Subject: Material for today's Light-duty GHG NPRM discussion.

Summary points from EPA review of CAFE model (NPRM version) – Effect of EPA code revisions

Meeting with Office of Management and Budget/OIRA

Growth in Fleet Size Due to Scrappage Model

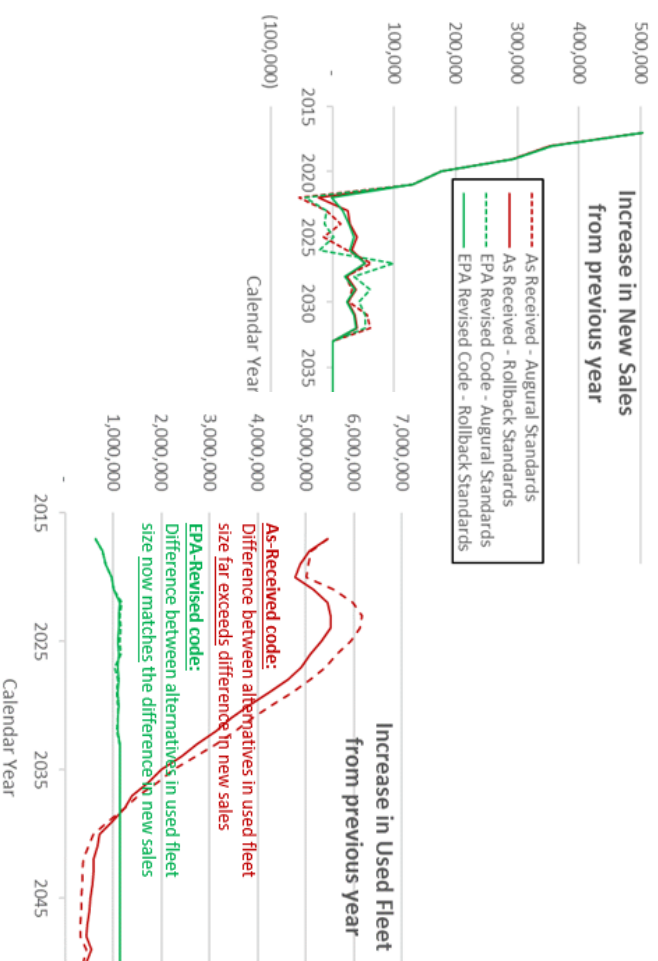
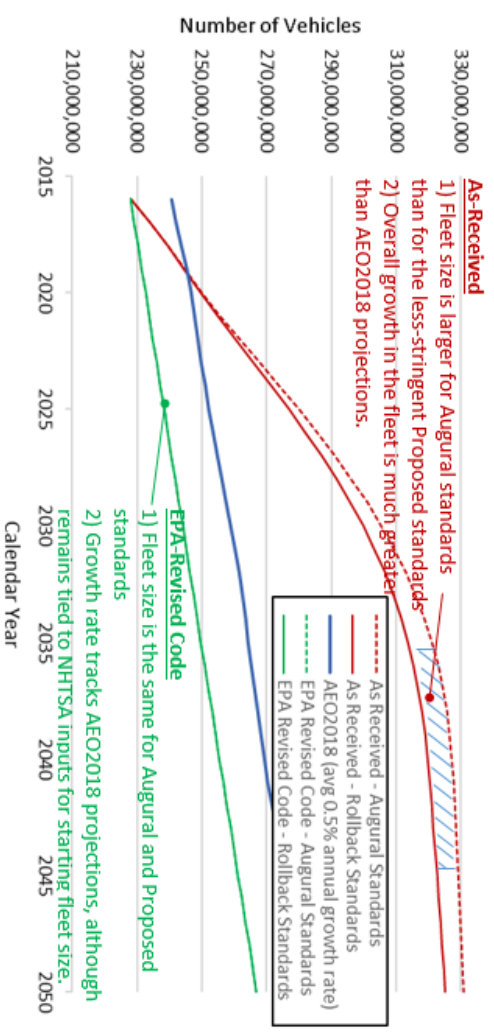
The new vehicle sales model produces small reductions in projected sales under the Augural standards, while the scrappage model projects an increase in fleet size that far outweighs the sales reductions (by a factor of 60:1.) The combined result is a fleet size that grows much more rapidly than AEO projections.

Specific the overall fleet growth as an input, and scale the scrappage rate curves (maintain the new sales model as is)

Growth in VMT beyond the intended rebound-related increase

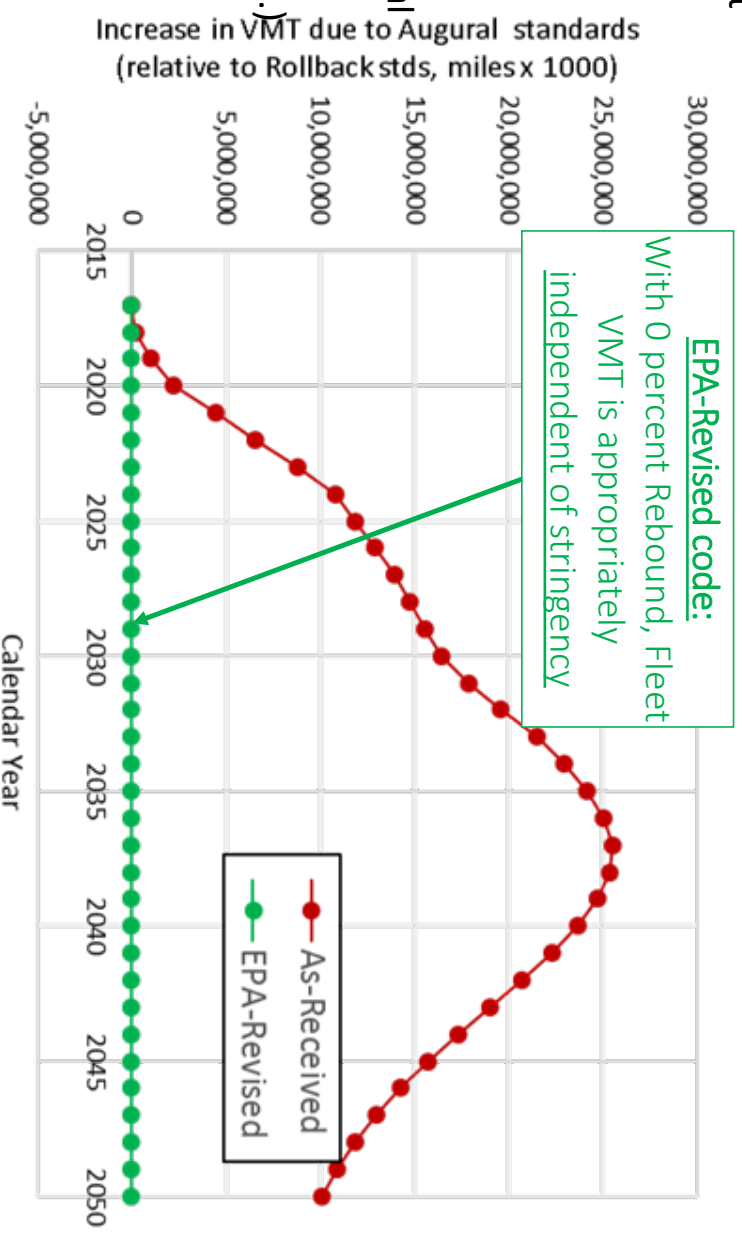
Per-vehicle VMT schedules are fixed, and not dependent on the scrappage model. As a result, total VMT can vary in an unexpected/unintended ways (e.g., VMT changes with zero rebound, zero rebound growth more expensive new and used vehicles.)

Scale per-vehicle VMT schedules so that total VMT is consistent with definition of rebound (i.e. Total VMT remains constant across regulatory alternatives at 0 percent rebound.)

Figure 2 Year-over-year increase in new vehicle sales (left) and increase in used fleet size (right) using As-Received CAFE model (note the difference in y-axis scale)

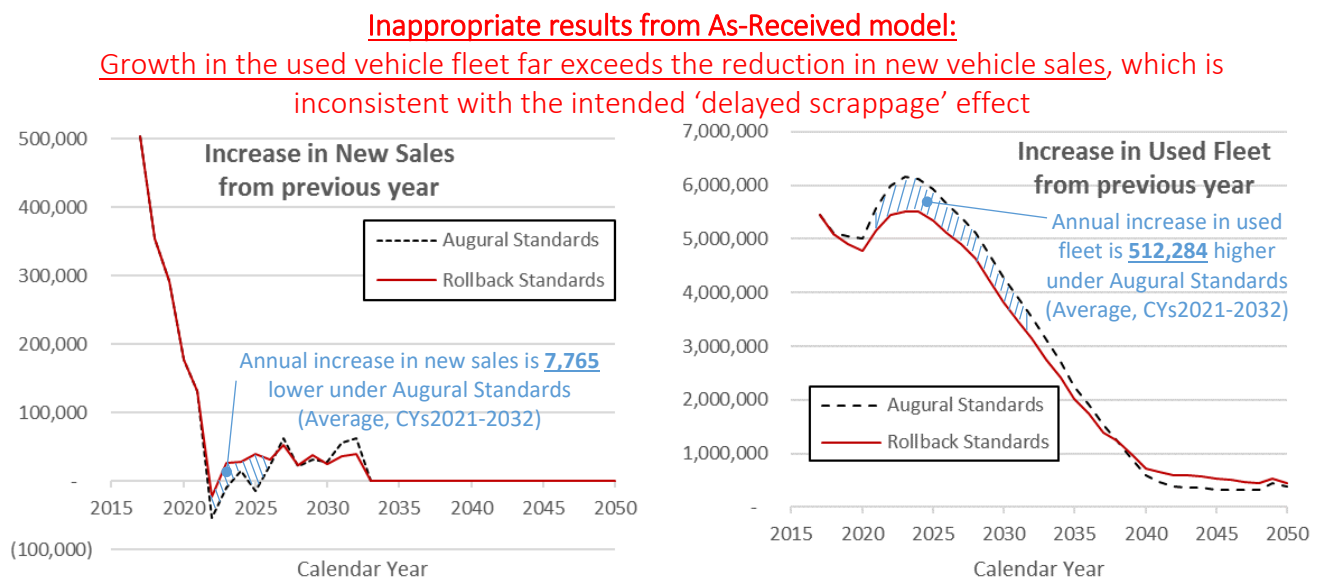
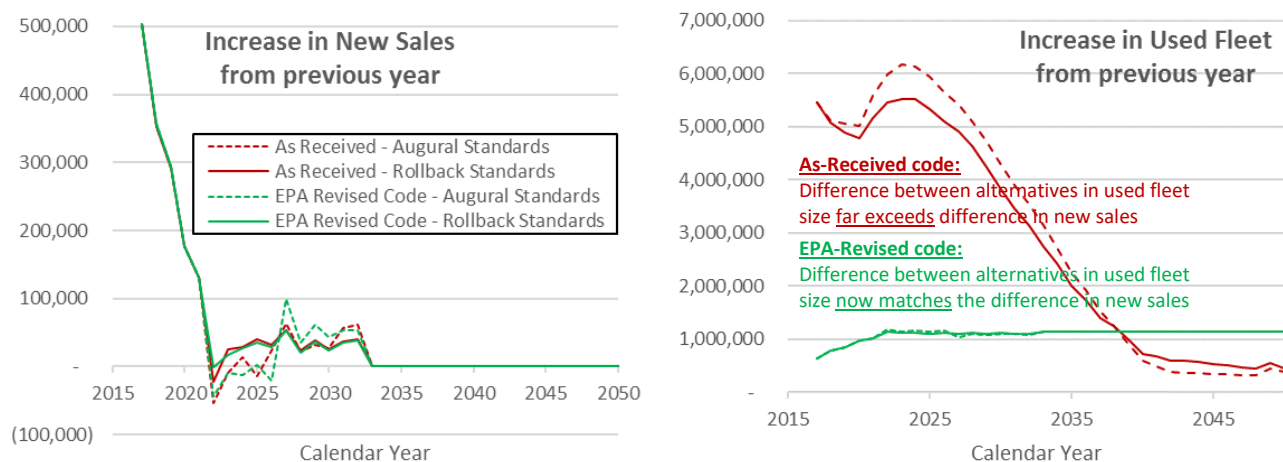
The effect of the disconnect between the new sales and scrappage models in the As-Received version is illustrated in Figure 2. Both the new sales fleet (i.e. vehicles of age 0) and the used fleet (i.e. vehicles of age greater than 0) generally increase year-over-year in the Augural and Proposed cases. For the used fleet, this is an expected trend since new vehicle prices and GDP increase for both the Augural and

While directionally those trends are logical, the difference in the magnitude of impact the Augural standards have on the new sales and scrappage models is difficult to justify. The As-Received model estimates that the Augural standards will reduce the year-over-year annual increase sales of new vehicles by approximately 8,000 vehicles on average between CY2021 and CY2032. However, during the same period, the As-Received model estimates that the used fleet will grow by an average of 512,000 vehicles per year, far exceeding the decrease in new vehicle sales. It's hard to imagine any real-world scenario under which over 60 additional used vehicles are retained for each new vehicle that the sales model predicts will be unsold as a result of the higher new vehicle prices.

Figure 12 EPA Revised Code Effects, Compare to As-Received CAFE model results in Figure 2:
 “Year-over-year increase in new vehicle sales (left) and increase in used fleet size (right) using As-Received CAFE model (note the difference in y-axis scale)”

Figure 3 Total fleet size in As-Received CAFE model (AEO 2018 0.5% growth rate shown for reference)

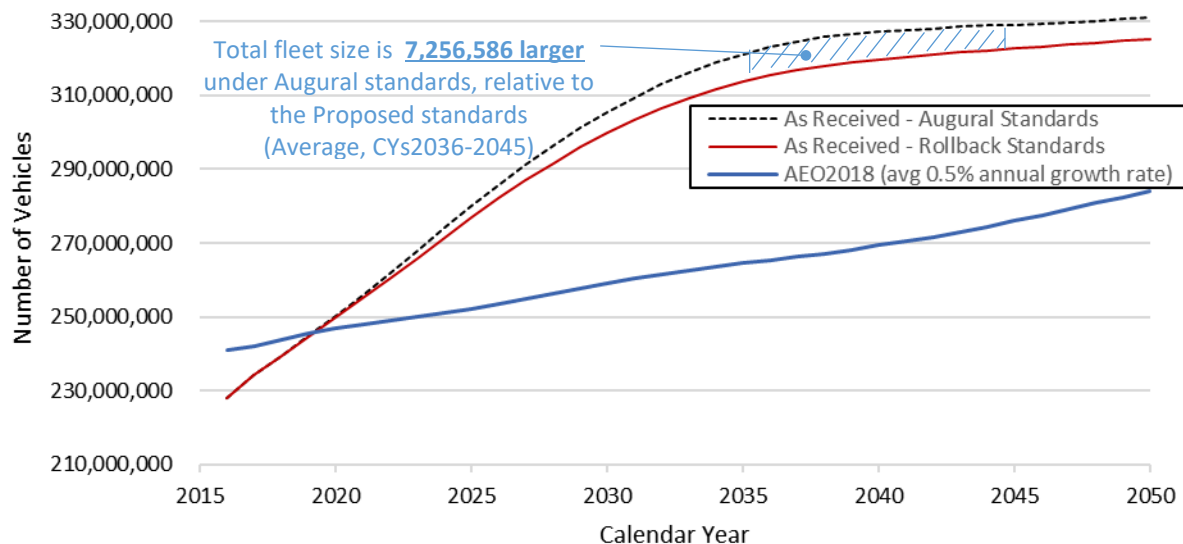
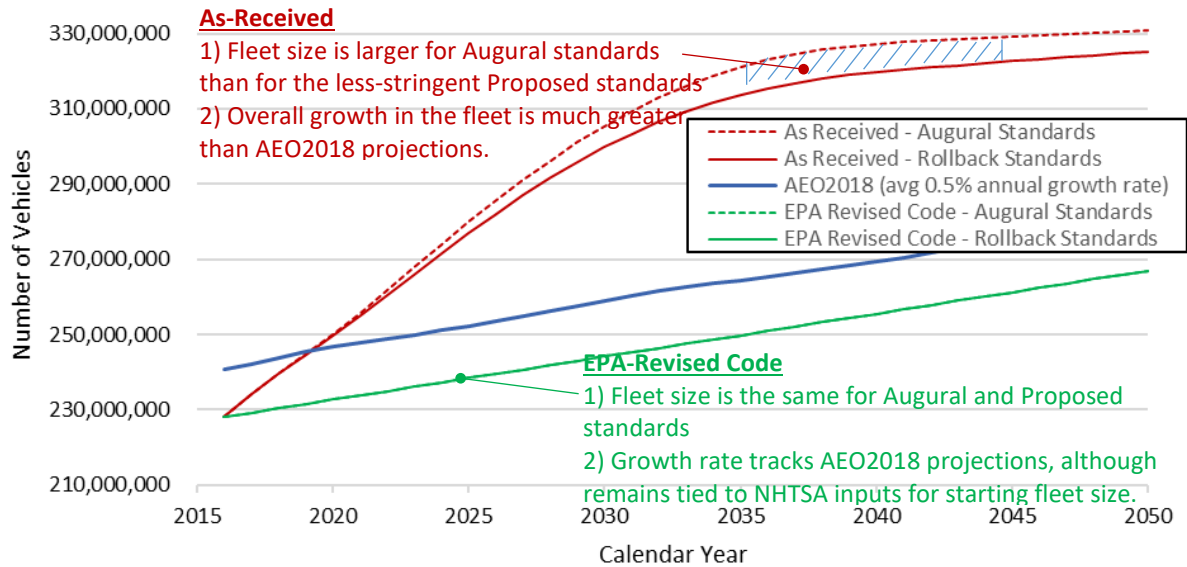
Figure 3 shows the combined effect of the new vehicle sales model and the scrappage model in the As-Received version of the CAFE model. A change in the overall fleet size due to the Augural standards might not in and of itself be problematic, as long as the VMT schedules are adjusted to account for overall travel activity that is distributed over a larger number of vehicles. However, the As-Received version of the model does not adjust VMT schedules, with the result that the additional unscrapped vehicles inflate total VMT proportionately. During the period over which the summary statistics for fatalities are reported in the draft NPRM (CYs 2036-2045), the difference in the estimated fleet sizes between the Augural and Proposed standards is approximately 7 million vehicles, or over 2% of the

Total Fleet size grows with increases in stringency and cost of new and used vehicles, which is not consistent with the basic principle of supply and demand

EPA modified the CAFE model to align with the NHTSA’s stated intent, so that the scrappage model predicts fleet composition, but does not dictate total fleet size. Our modified code allows the user to select a fleet growth rate (we have used the AEO value of 0.5% growth per year by default, but other rates could be used.) Our code then allows the model to run as usual to determine new vehicle sales and the composition of the used vehicle fleet. These values are then used to scale the size of the used vehicle fleet (maintaining the predicted composition) to achieve the user-provided growth in fleet size. This way the new vehicle sales are identical to the As-Received values, the used vehicle fleet has the identical composition as the As-Received values, but the fleet size grows at much more reasonable rates.

Figure 13 EPA Revised Code Effects, Compare to As-Received CAFE model results in Figure 3: “Total fleet size in As-Received CAFE model”

Figure 4 Change in VMT due to 20 percent rebound with As-Received model, Proposed standards case (change shown is relative to 0 percent rebound)

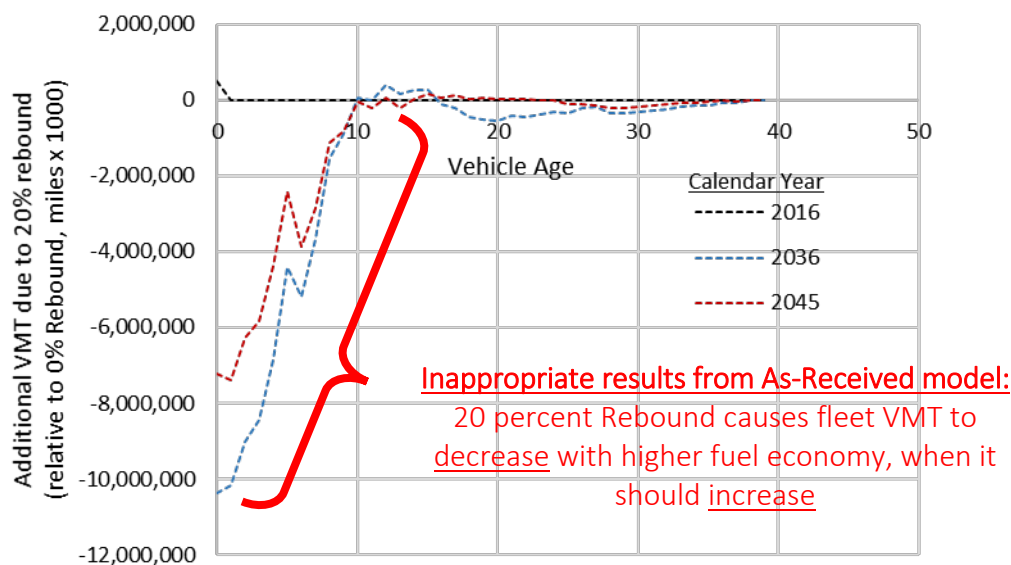
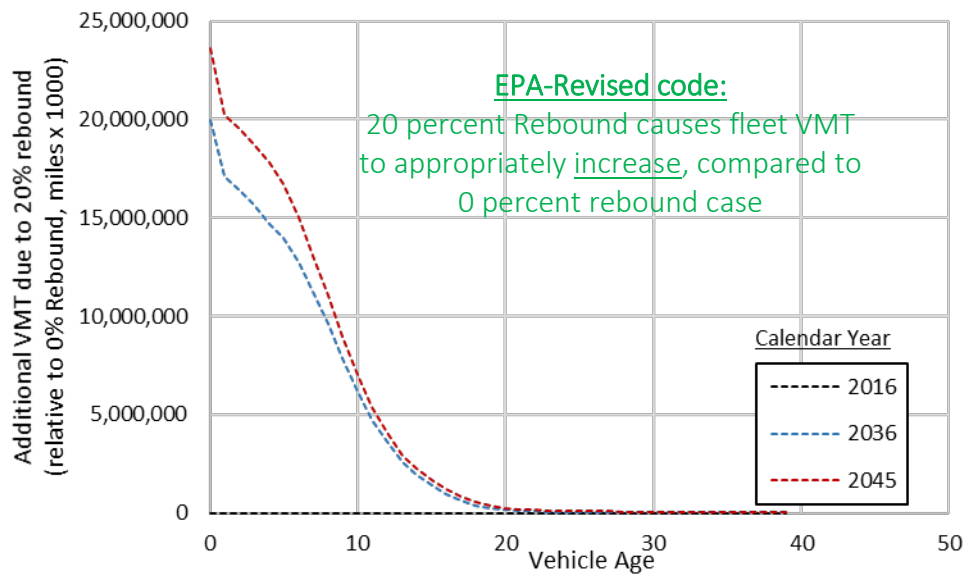
One of the problems with the implementation of the rebound calculations in the code of the As-Received model is illustrated in Figure 4 for the Proposed standards. In this case, the inclusion of 20 percent rebound causes a reduction in VMT in future calendar years, despite the fact the Proposed standards produce a fleet with higher fuel economy and lower cost per mile than the baseline (MY2016) fleet. This result is clearly inappropriate, since by definition the rebound effect should result in more miles driven as cost per mile decreases.

After reviewing the CAFE model code, we have determined that the directionally incorrect reduction in total fleet VMT with 20 percent rebound shown in Figure 4 and Figure 5 above is due to the combined effect of two problematic assumptions used for calculating the reference cost per mile (CPM_{ref}) in Equation 1. The first assumption is the use of a constant CY2016 fuel price to calculate CPM_{ref}, even as CPM_{new} is calculated using the future year's fuel price. The consequence of using two fuel prices that diverge further with each year (due to future projected increases in fuel prices) is that VMT calculated from Equation 2 becomes lower over time, independent of any changes in fuel economy. Such a result is unjustified since it ignores the economic and income growth that is projected to occur concurrently with fuel price increases.

Figure 14 EPA Revised Code Effects, Compare to As-Received CAFE model results in Figure 4: “Change in VMT due to 20 percent rebound, Proposed standards case (relative to 0 percent rebound)”

Figure 5 CPMrate variation by vehicle age and fuel economy improvements during redesign of 10 percent (left panel) and 50 percent (right panel)

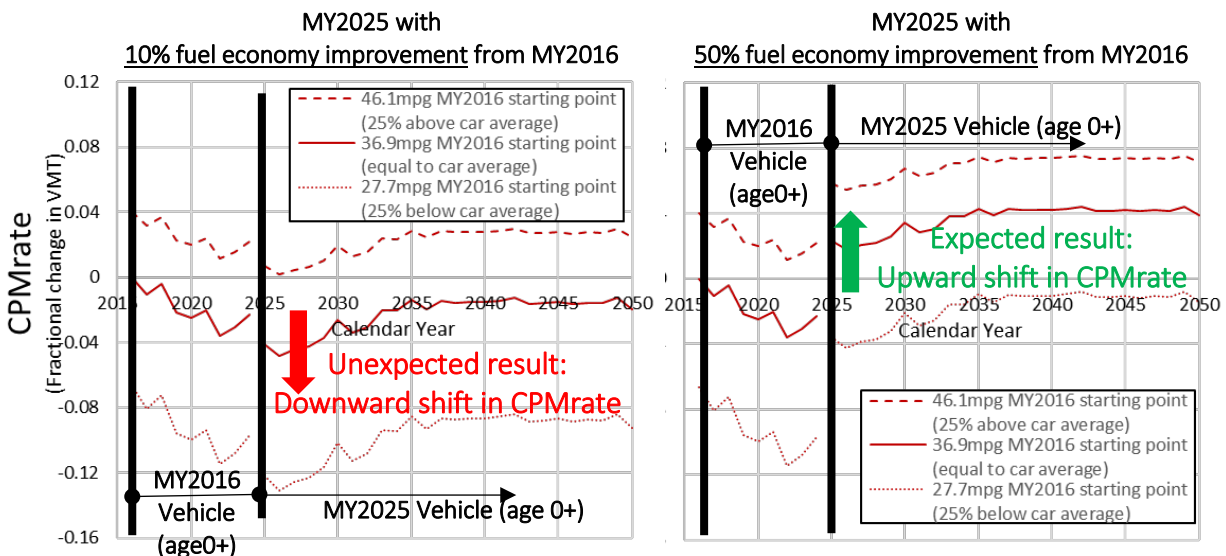
Figure 5 gives a closer view of the CPMrates determined from Equation 1 for three example vehicles, with MY2016 versions which maintain a constant fuel economy at levels equal to, 25 percent above, and 25 percent below an average MY2016 car.⁹ These values are maintained until a MY2025 redesign, when the fuel economy is improved by either 10 percent (left panel) or 50 percent (right panel) compared to the MY2016 versions.

One notable observation is how the CPMrates vary by calendar year as the individual vehicles age. This is unexpected, since the CPMrate is applied to the annual mileage values that already account for the progressive decline in the miles driven each year as vehicles age. What the age- or year-related phenomenon this variation in CPMrate would be intended to represent is not clear. Another notable observation is the inconsistency in the direction of change in CPMrate of the new MY2025 vehicle, relative to the 8-year old MY2016 vehicle in CY2024. When the MY2025 vehicle is 50 percent more fuel efficient than MY2016 (right panel of Figure 5), the CPMrate shifts upward, resulting in higher VMT for the vehicle with greater fuel economy as would be expected. However, when the MY2025 vehicle is only 10 percent more fuel efficient than MY2016 (left panel of Figure 5), the CPMrate shifts downward. This tendency to produce VMT reductions for newer vehicles with moderate levels of fuel economy improvement is consistent with the inappropriate VMT results shown in Figure 4 above, indicating that this issue is caused by the calculation of CPMrate within the CAFE model.

Figure 6 Change in VMT due August standards, with 0 percent rebound (relative to Proposed standards)

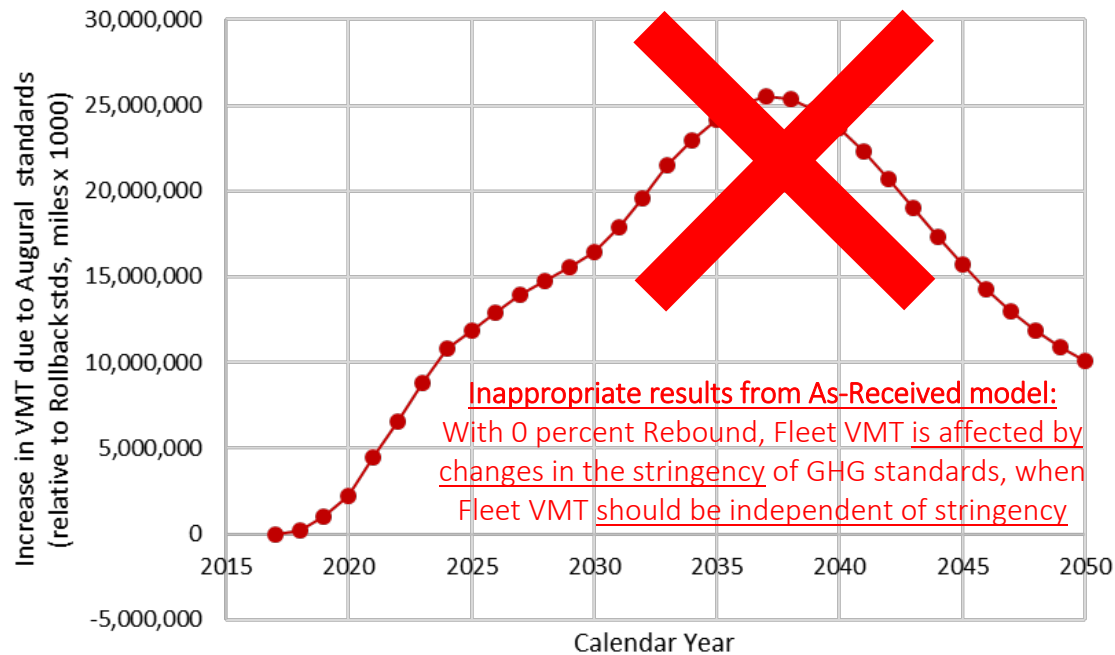
In addition to the problems described above with the As-Received model's implementation of the rebound effect, an additional inconsistency between VMT estimates generated by the model and the specified rebound value became evident when we looked at the VMT results for alternatives with different stringencies, holding rebound at 0 percent.¹⁰ With no rebound, we would not expect to see any change in total VMT, since by definition rebound is measured as the change in VMT for a given change in fuel cost per mile. However, even with 0 percent rebound, the As-Received model does produce total VMT values that are influenced by stringency level. See Figure 6, below. We believe that this zero-rebound VMT growth is an artifact of the disconnect between the sales model, scrappage model and mileage accumulation schedules described with Issue #1. And while this problem is not directly related to the model's calculation of the rebound effect, it points to the importance of carefully considering how the various elements are integrated when making changes or additions to a model.

In total, the As-Received model 1) inappropriately incorporates a vehicle age-related effect due to rebound, 2) exhibits directionally incorrect VMT changes in response to fuel economy improvements, and 3) produces a VMT response to changes in stringency even when the rebound value is set to 0. We conclude that the model's implementation of the rebound effect is inappropriate, and that the model code produces VMT values that are inconsistent with the 20 percent rebound value that is specified in the input files. As with the problems described for the Scrappage Model in Issue #1, resolving the problems with the CAFE model's implementation of the rebound effect is critically important. An inappropriate accounting of the rebound effect will produce unreliable VMT estimates, which in turn will produce unreliable estimates of net fuel savings, emissions costs, fatalities, etc., making it impossible to accurately evaluate and compare the various policy alternatives.

Figure 7 Effect of CPMref assumptions on CPMrate with 20 percent rebound (hypothetical example shown for MY2025 vehicle with 10 percent fuel economy improvement from MY2016 vehicle)

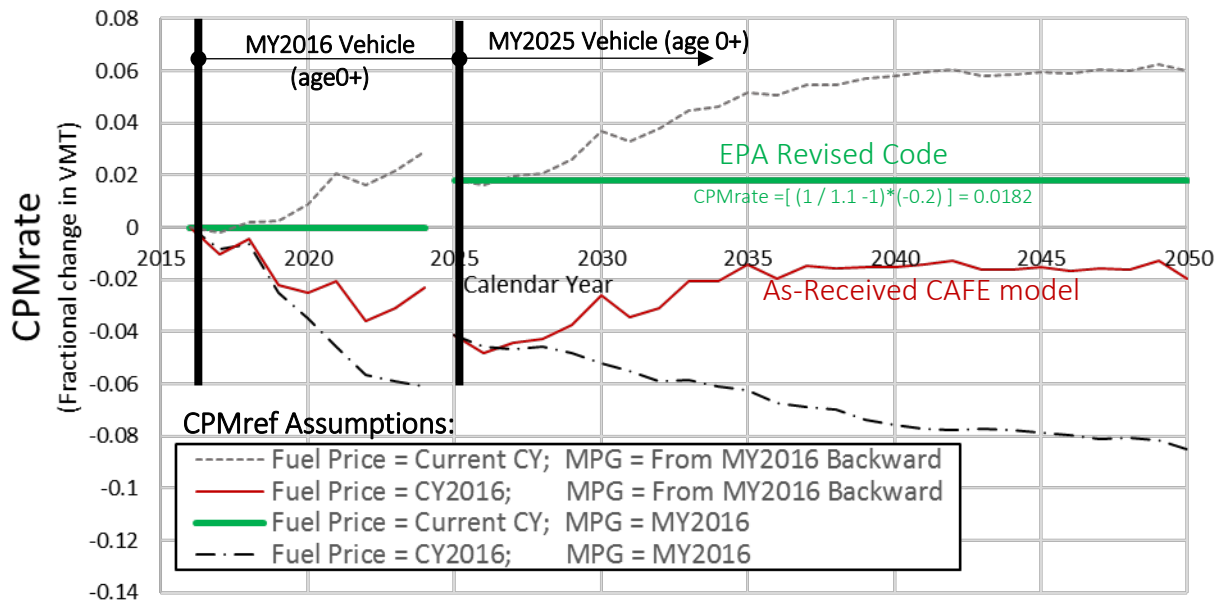
A hypothetical example will help to illustrate the importance of making appropriate assumptions when selecting CPMref. Building off the example in Figure 5 with MY2025 improvements to an average MY2016 car with fuel economy of 36.9mpg, Figure 7 shows how the CPMrate (and therefore the VMT) can change dramatically based on assumptions for CPMref. The inappropriate referencing of progressively older fleet average fuel economy values (red and gray curves), causes the CPMrate to be higher than when constant MY2016 reference fuel economy values are used (black and green curves.) The inappropriate referencing of CY2016 fuel prices (red and black curves) causes the CPMrate to be lower than when the current CY fuel prices are used (gray and green curves.) While these two problematic assumptions for CPMref tend to work in opposite directions, the general tendency of the As-Received model to produce a negative CPMrate in the example in Figure 7, despite the improvement in fuel economy, seems to indicate the assumption of maintaining CY2016 fuel prices is dominant.

We believe that the most defensible implementation of the rebound effect is one that maintains the same CPMrate over every calendar year in the course of a vehicle lifespan. In the example shown by the green line in Figure 7, the CPMrate for the MY2025 vehicle then becomes simply a function of the ratio of the reference fuel economy to the new fuel economy and the 20 percent rebound effect value, or $[(1 / 1.1 - 1) * (-0.2)] = 0.0182$. To achieve this, we revised the CAFE model code so that:
